# **RESPONSES TO COMMENTS ON THE DRAFT ENVIRONMENTAL IMPACT REPORT**

## **SFPUC Alameda Creek Recapture Project Volume 3**

PLANNING DEPARTMENT  
 CASE NO. 2015-004827ENV  
 STATE CLEARINGHOUSE NO. 2015062072  
 JUNE 7, 2017

Re: **Responses to Comments on the Draft Environmental Impact Report for  
Case No. 2015-004827ENV, SFPUC Alameda Creek Recapture Project**

**Revised Figure 3-2**

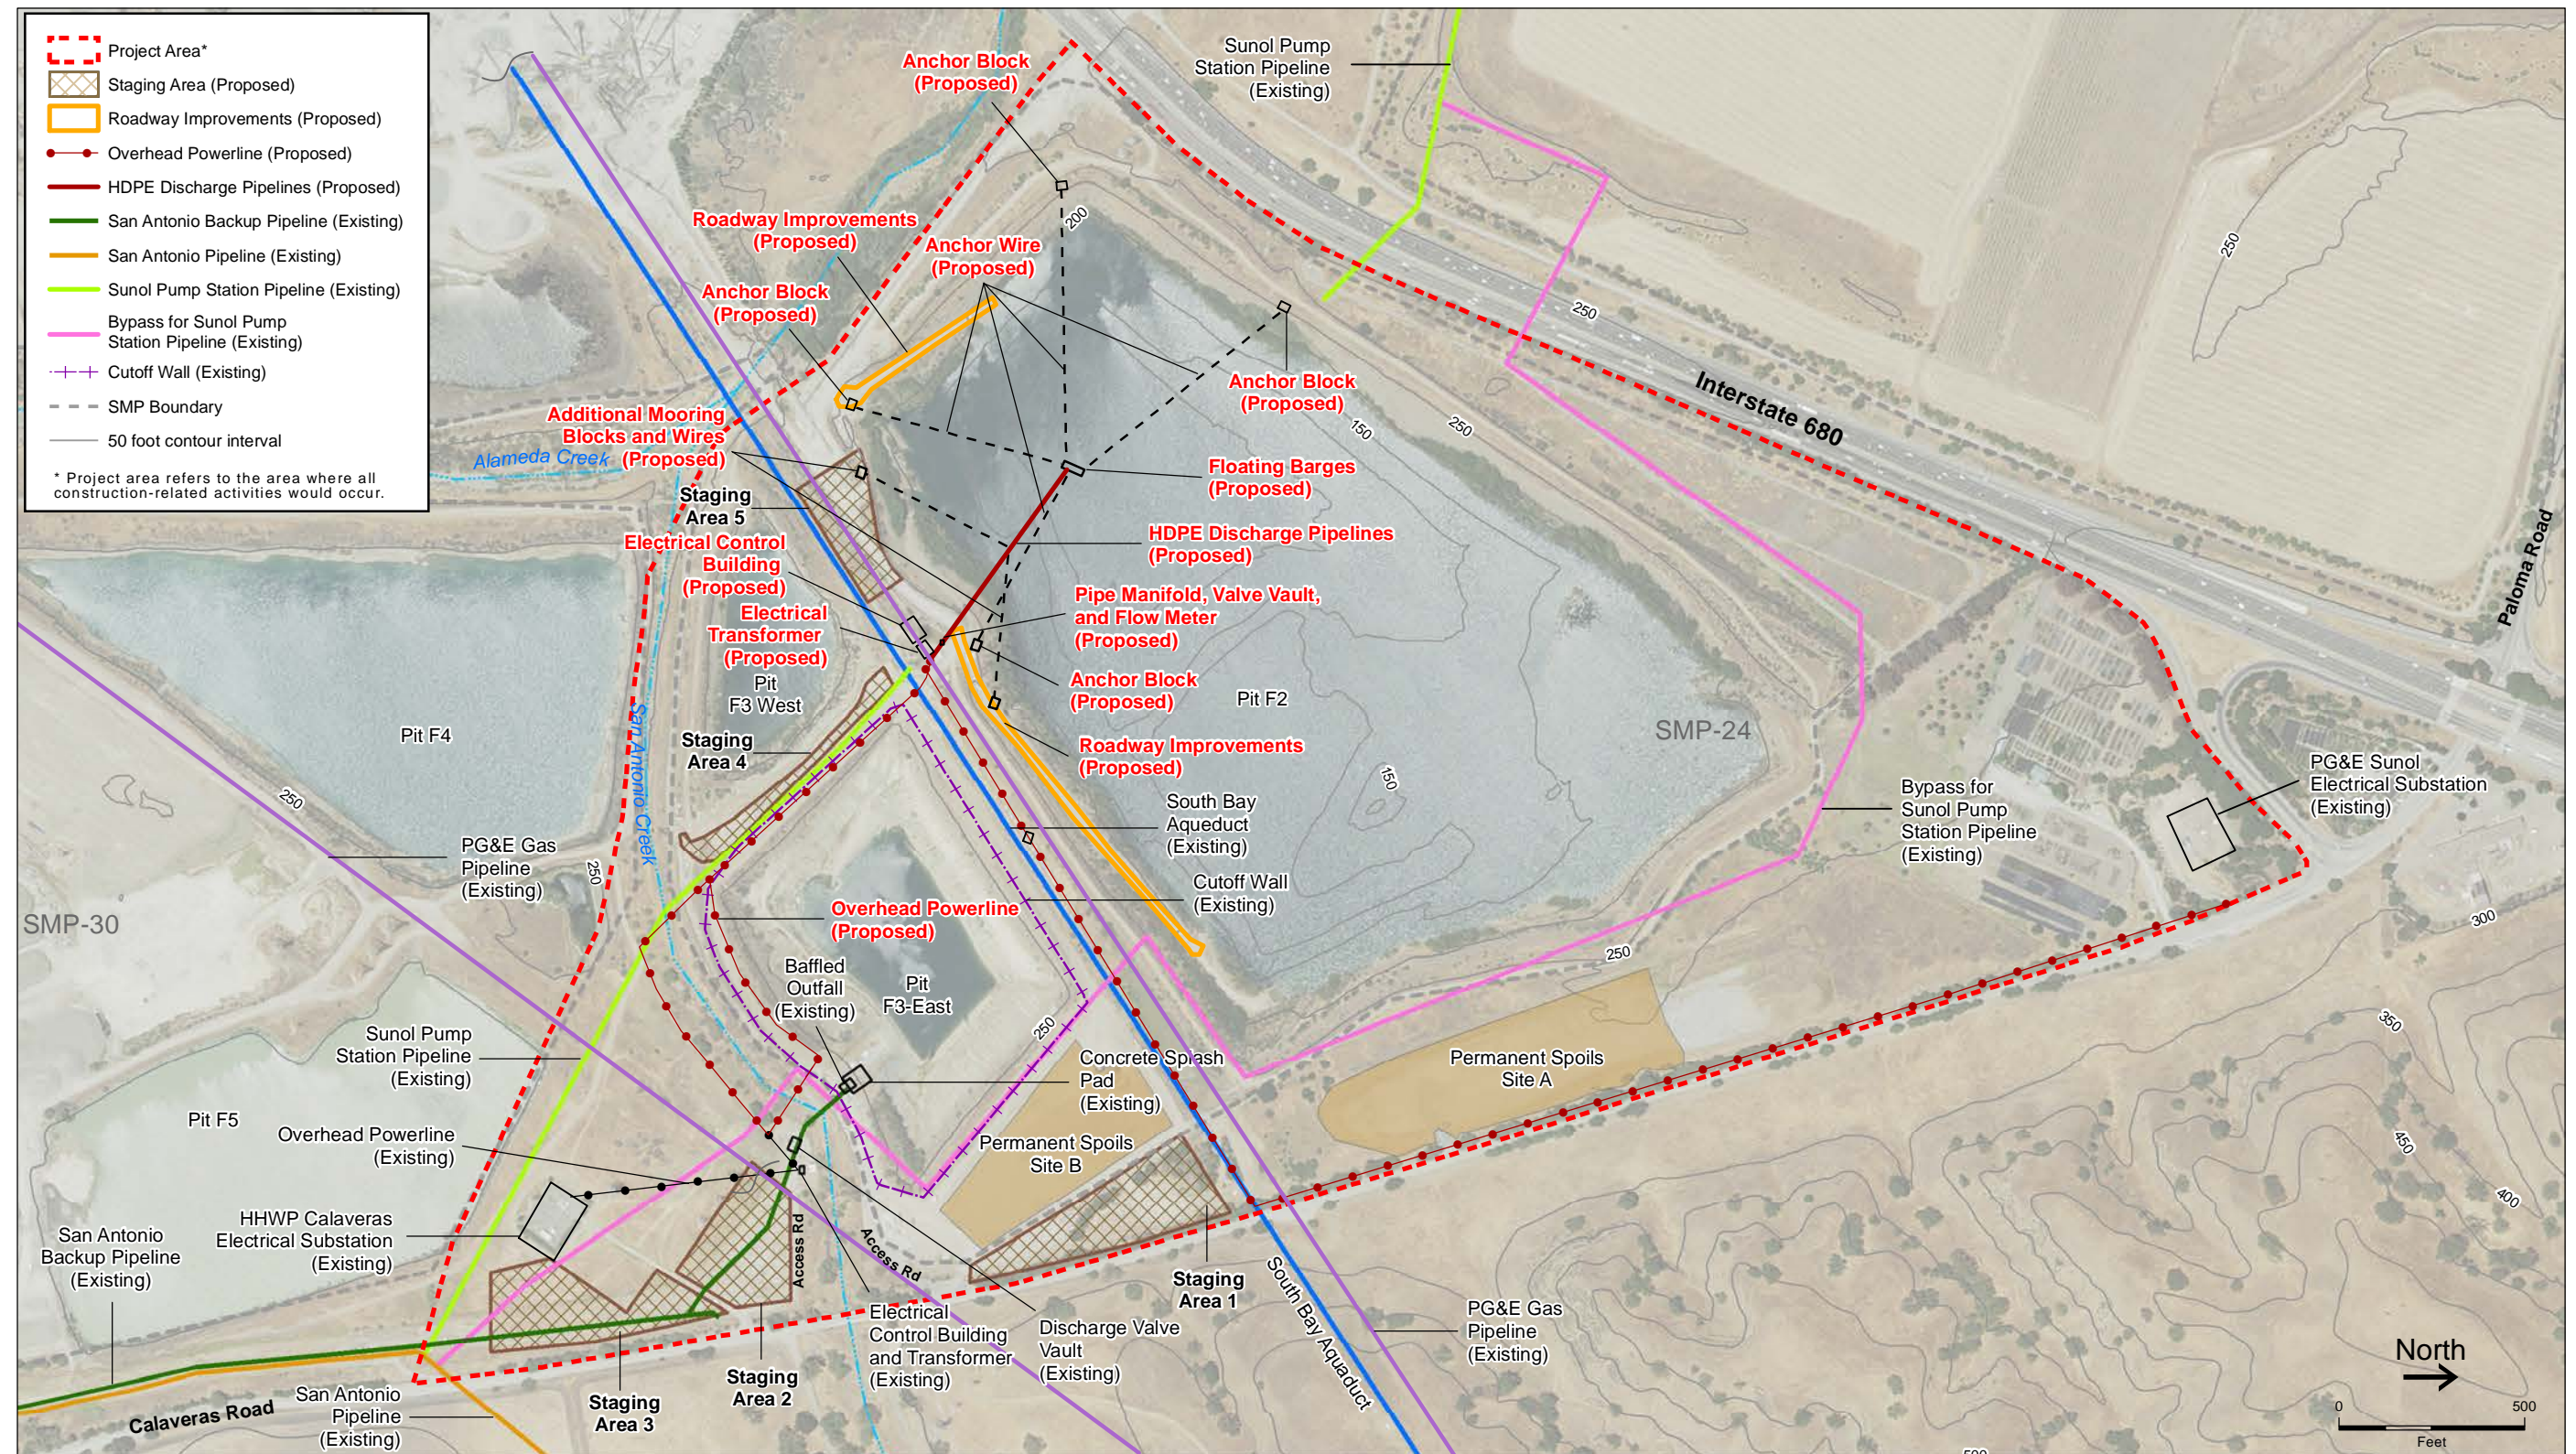
- 
- f. **The DEIR cumulative impacts do not include effects of cutoff walls.** Figure 1-1 of the DEIR displays existing cutoff walls around Pit F2, which were installed to minimize seepage of Alameda Creek surface water into the groundwater basin and into Pit F2. The figure also displays proposed future cutoff walls around sections of Pit F6. Installation of this future cutoff wall will likely provide additional protection from surface streamflow losses to the Sunol groundwater basin. The hydrologic analysis must be refined to include the proposed cutoff wall, and any associated changes in streamflow loss rate to determine cumulative impacts and adequately model future streamflow conditions through this reach (CEQA Guidelines §§ 15065(a)(3), 15130). (Robert Shaver, General Manager, Alameda County Water District, January 30, 2017, A-ACWD2-10)
-

As discussed in Response HY-9, Figure 3-2, page 3-5, has been revised to remove the proposed cutoff wall because it currently does not exist, as shown on page 12-7. See Revised Figure 3-2.
